Bulletin No.: 14888C
Date: June 2015

Recall Bulletin

SUBJECT: Front-Brake Caliper Leak

MODELS: 2015 Chevrolet Colorado
2015 GMC Canyon

Front Caliper Body Casting: Outboard Body

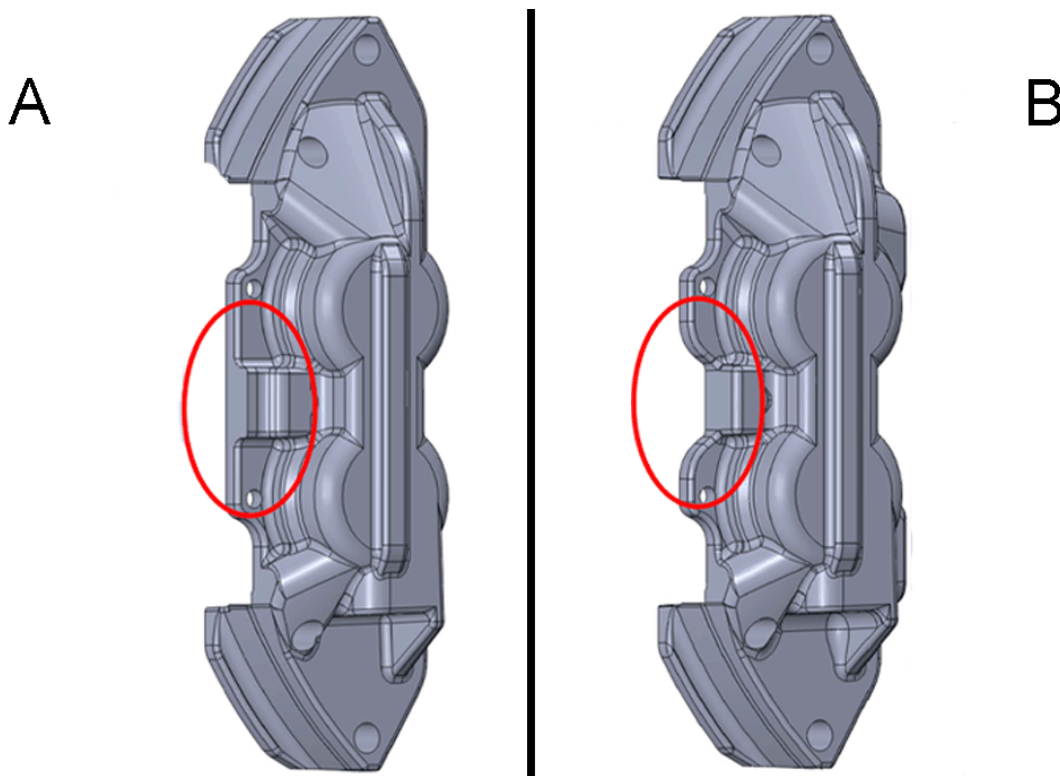
(A) Original Design Front Caliper Body Casting (B) New Design Front Caliper Body Casting. The shape of the pin ledge is different between the two designs. Refer to the area in the circles of the illustration to review the differences in the shape of the pin ledge from the original design to the new design.

3. Perform a visual inspection of the front calipers to determine the body casting design of the caliper.
 - If the vehicle is equipped with the original design front caliper body casting, remove and replace both front calipers. Proceed to step 4.
 - If the vehicle is equipped with the new design front caliper body casting, no further action is required. Install the tire and wheel assembly and lower the vehicle. Refer to *Tire and Wheel Removal and Installation* and *Lifting and Jacking the Vehicle* in SI.
 4. Remove the front brake calipers from the vehicle. Refer to *Front Brake Caliper Replacement* in SI.
- Note:** Transfer the brake pads from the old calipers to the new calipers BEFORE discarding the brake calipers.
5. Discard the front brake calipers.
 6. Install new front brake calipers to the vehicle. Refer to *Front Brake Caliper Replacement* in SI.
